**ADDENDUM NO. 1**

**March 8, 2024**

CEDAR KEY  
SANITARY SEWER  
LIFT STATION  
REHABILITATION

#### CONSTRUCTION KEY NOTES:

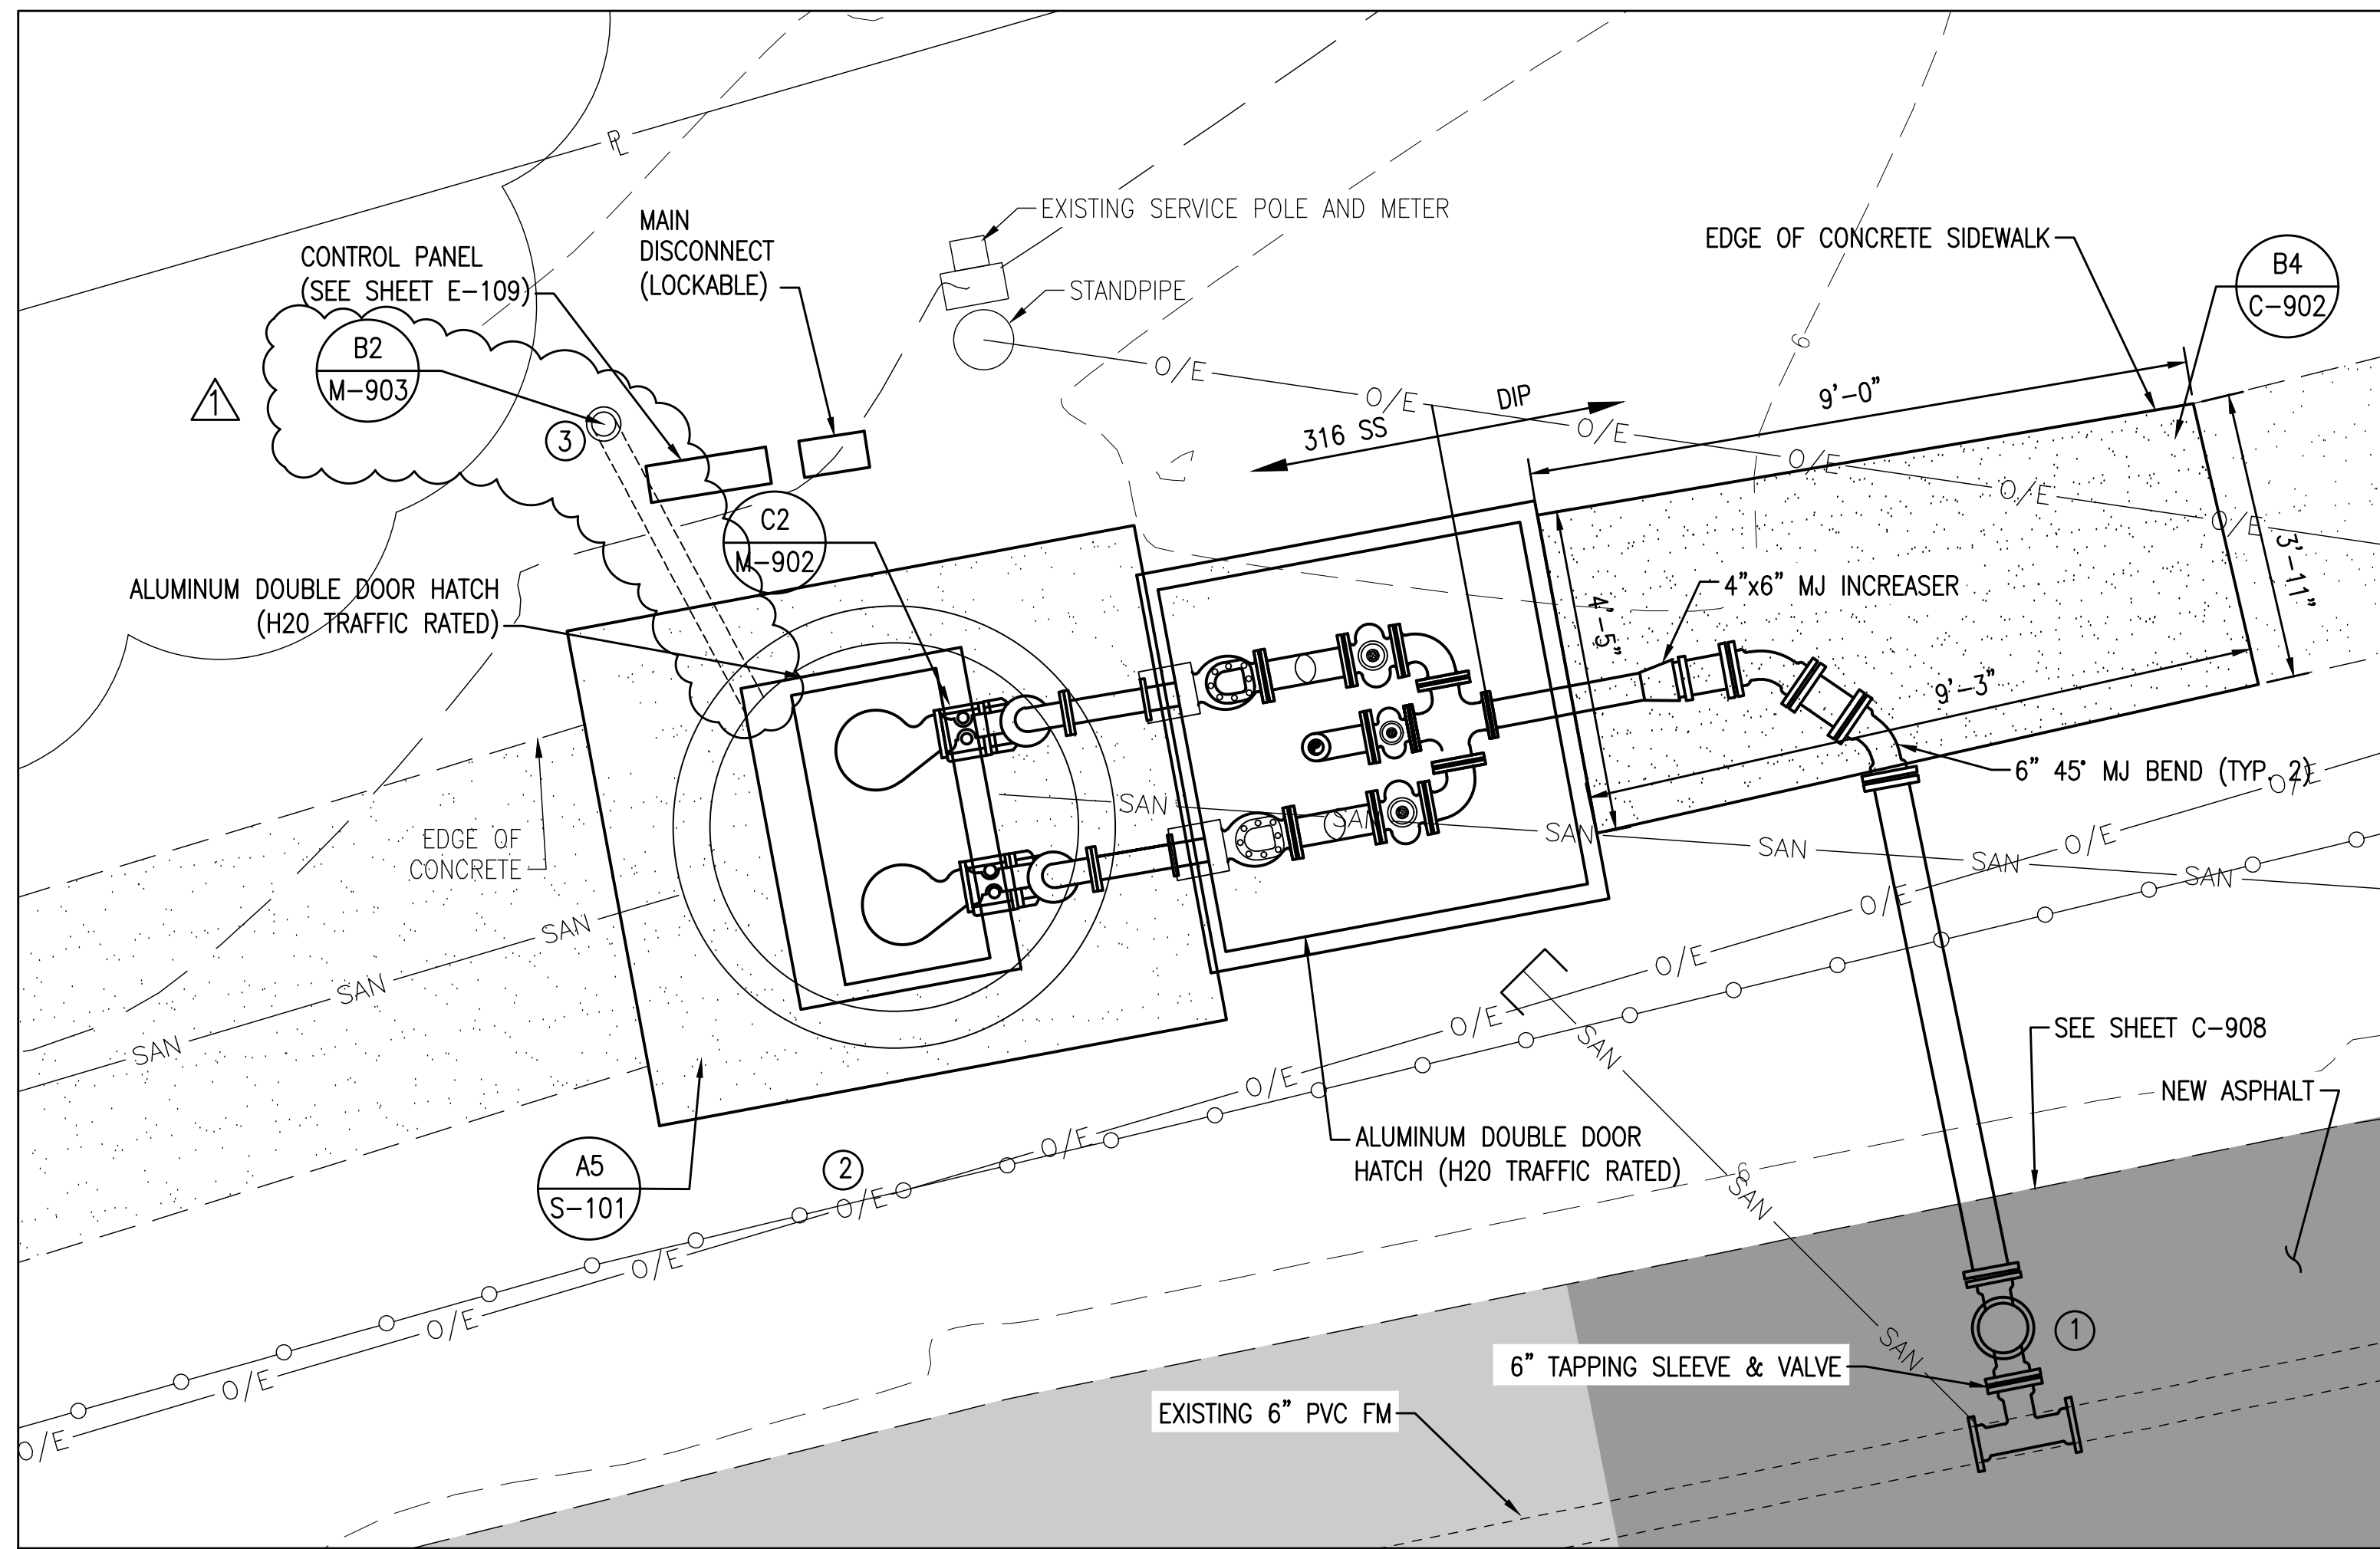
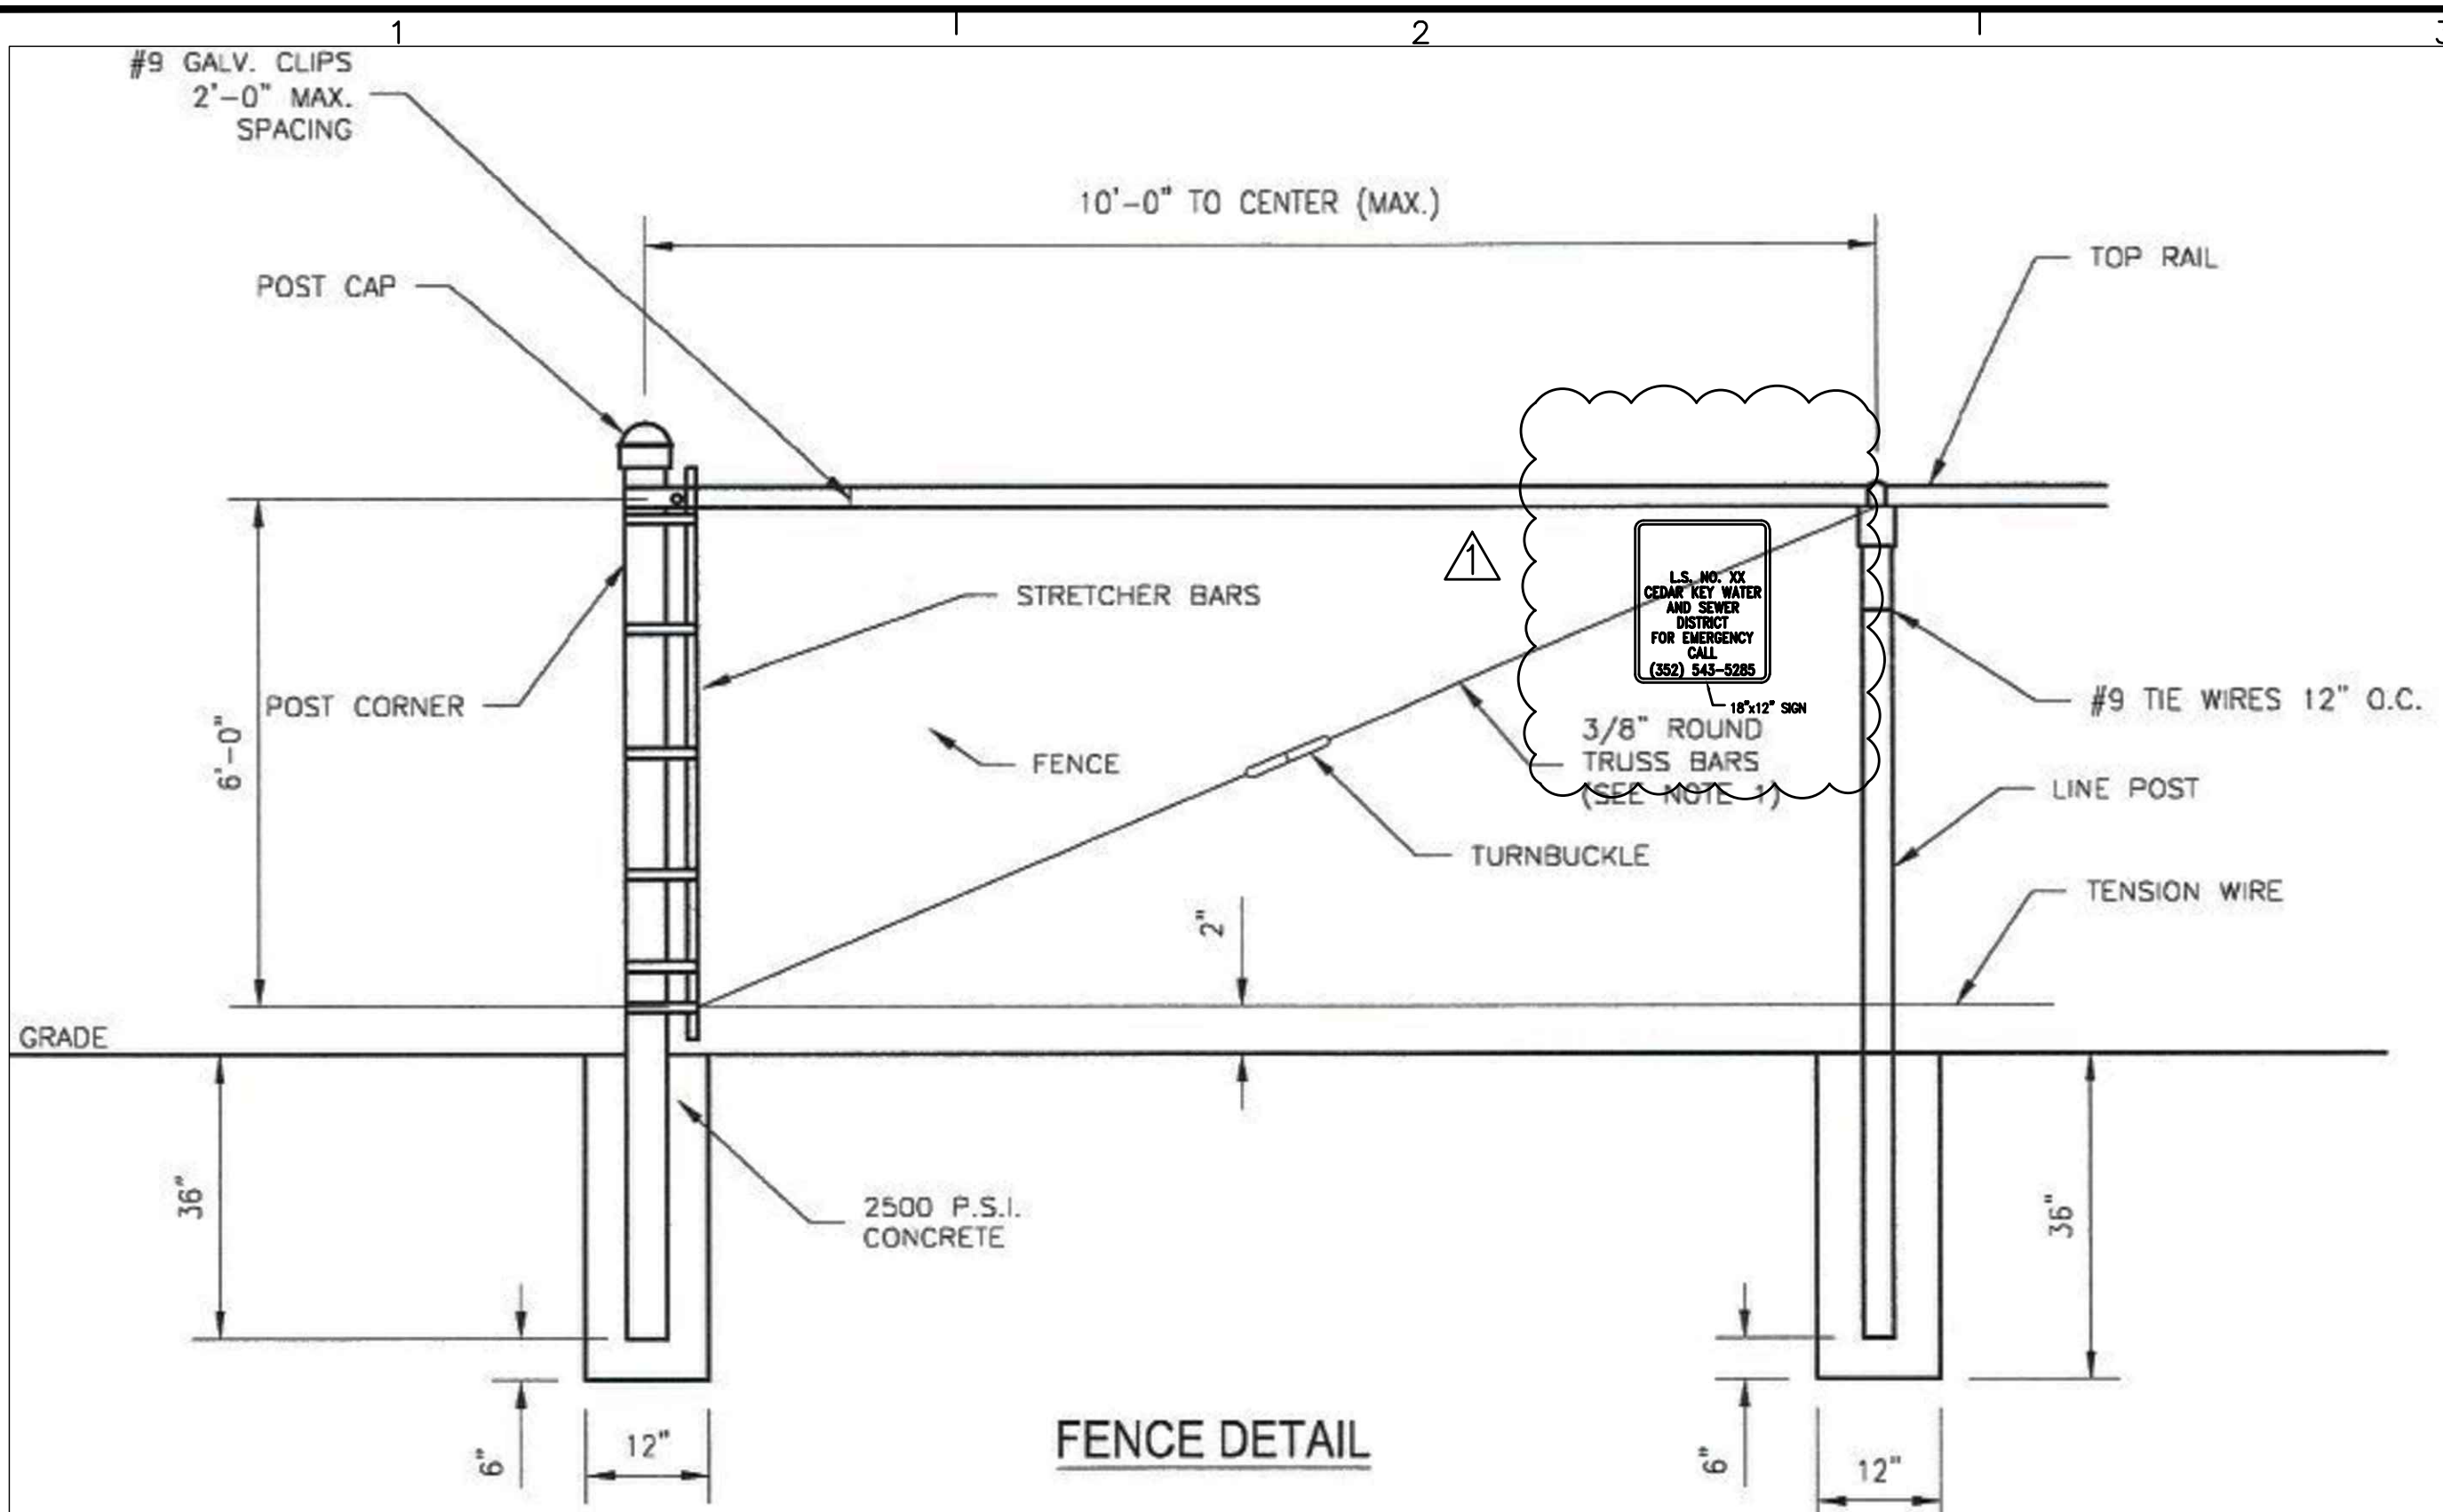
<b>SHEET NO.</b>	<b>CHANGE</b>
C-103	Updated drawing to include three (3) Removable Traffic Rated Bollard. The proposed fence was removed and the proposed gravel for the site was updated accordingly. The Contractor is required to install an emergency contact sign at the Lift Station 6 site.
C-104	Updated drawing to include a Demolition Hatch for the removal of the Existing Air Vent
C-105	Updated drawing to include 4" SS Air Vent to Lift Station 7
C-900	Updated drawing to include an Emergency Contact sign at each lift station site. The Contractor is required to install the emergency contact sign at Lift Station 6 too.
C-902	Updated drawing to include Removable Locking Bollards Detail
M-901	Updated drawing to include the correct pump HP requirements and updated the Emergency Shutoff Level
M-902	Updated drawing to include 4" SS Air Vent to the Lift Station 7 Detail and Updated the Emergency Shutoff Level

**B2** J-VENT DETAIL  
NOT TO SCALE

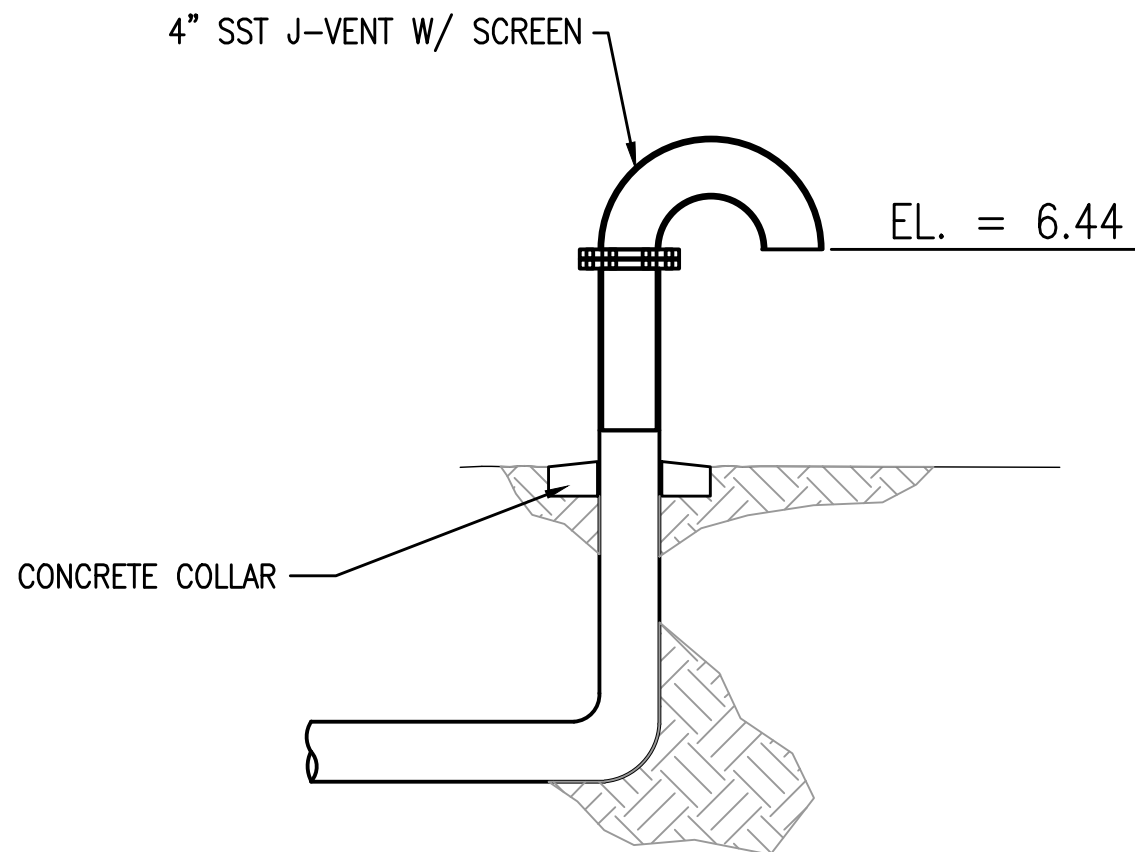
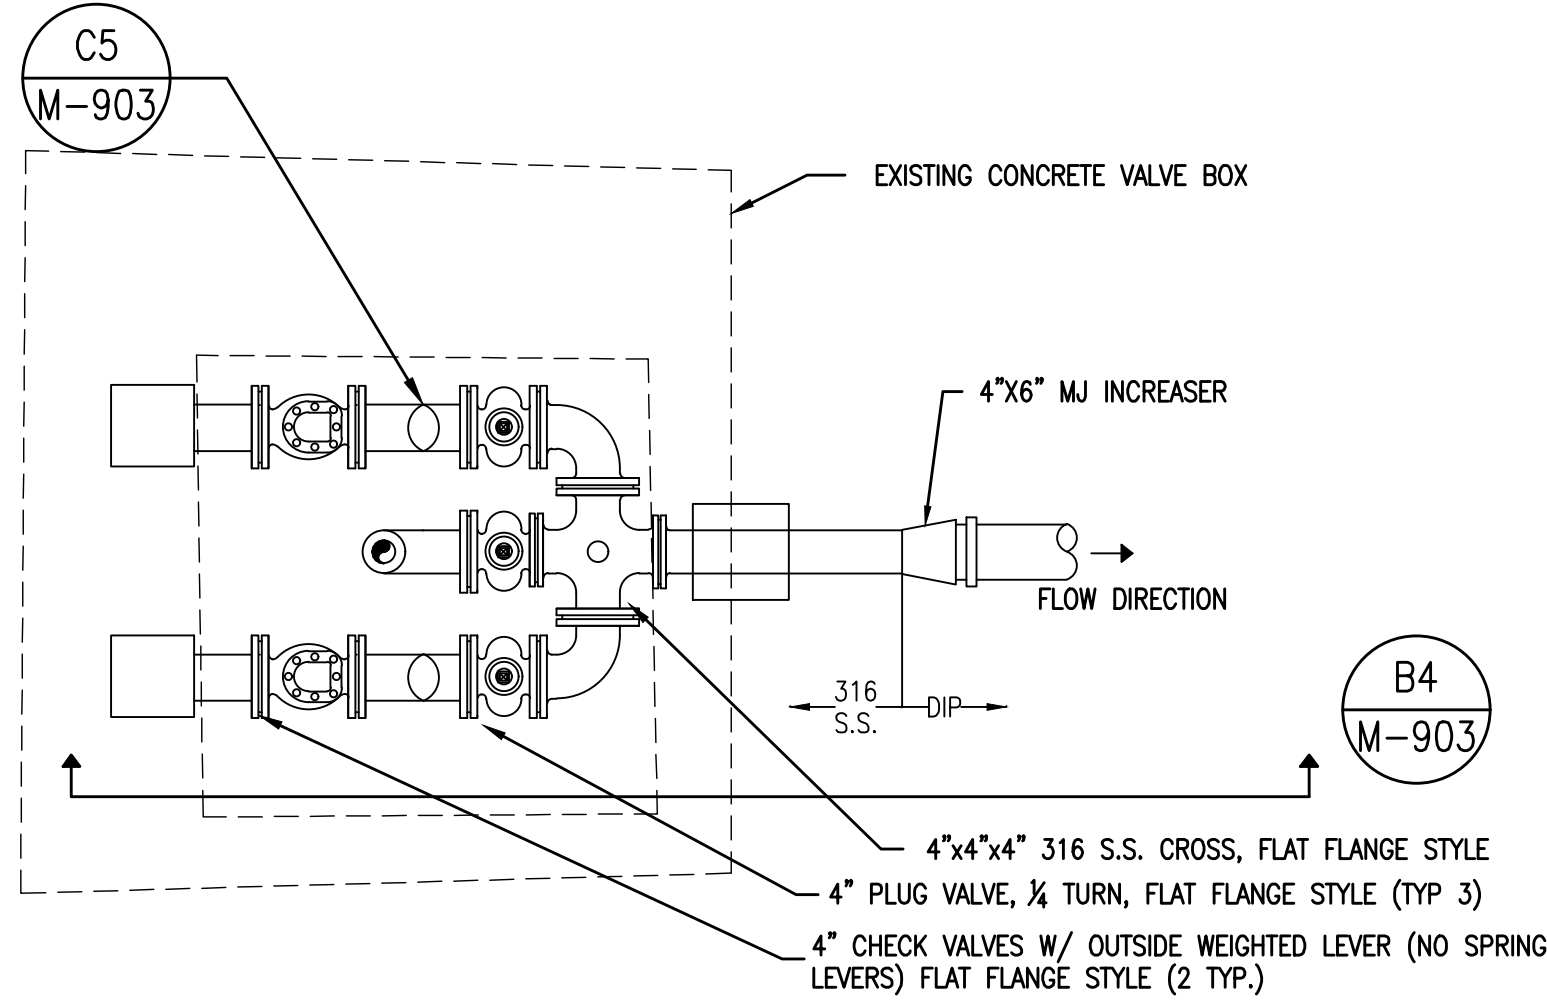
M-903	Updated drawing to include a 4" SS J-Vent Detail
E sheets	All electrical drawings were updated accordingly to reflect the correct pump motor HP requirement. All drawings sheets include updated notes for clarification.
